Re: **129 W. Genesee Street Splash Car Wash – Site Plan Review**

The following letter has been written in response to the review comments from Napierala Consulting dated August 18, 2022, received from the Village of Fayetteville on August 24, 2022. The following comments have been addressed below.

REV: 01
DRAWING NO: C7

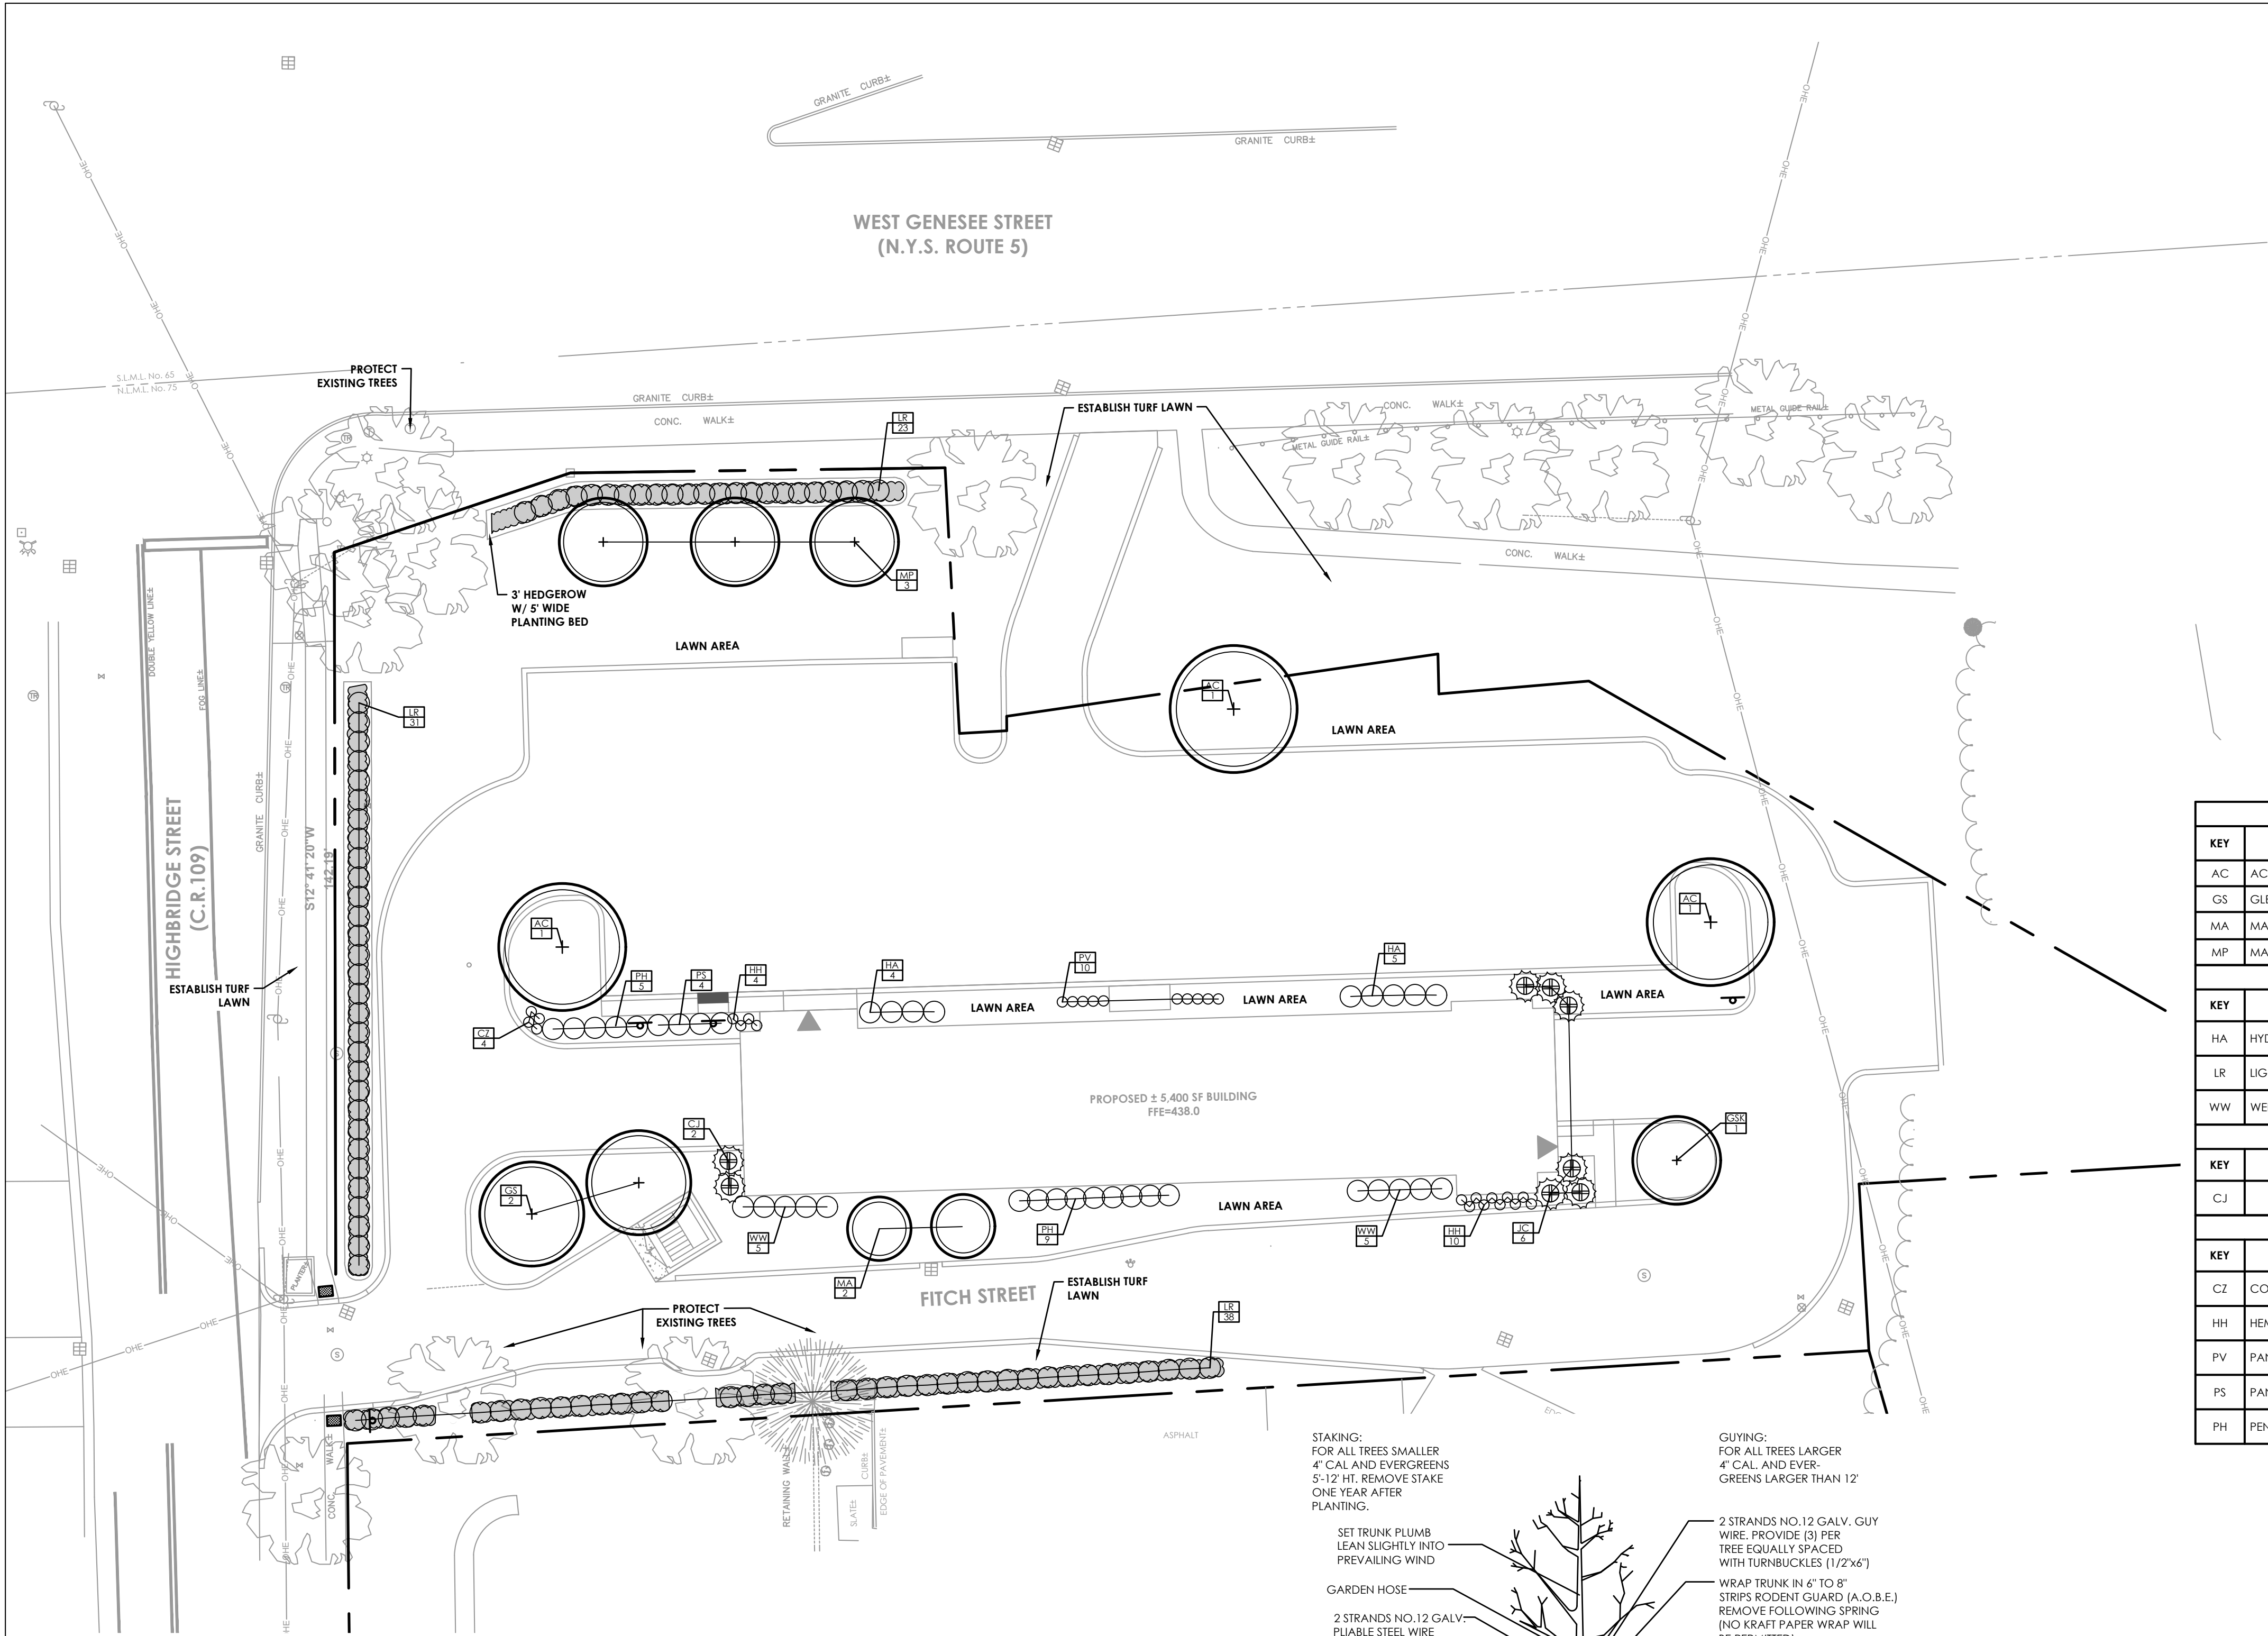
6) Landscape Plan, C7

- Lawn areas have been depicted on revised Landscape Plan.*
- c. Landscaping seems sparse around building. We defer to the planning board for the suggestion of additional landscaping.
Please see revised landscape plan, perimeter building plantings have been increased.

- d. Notes appear to be missing on the Tree Planting Detail.
Detail has been corrected on revised Landscape Plan.
- 7) Details, C8
- a. Dumpster enclosure - coordinate masonry block wall exterior finish and green vinyl chain link fence slats on swing gates with planning board.

Please see revised Landscape Plan.
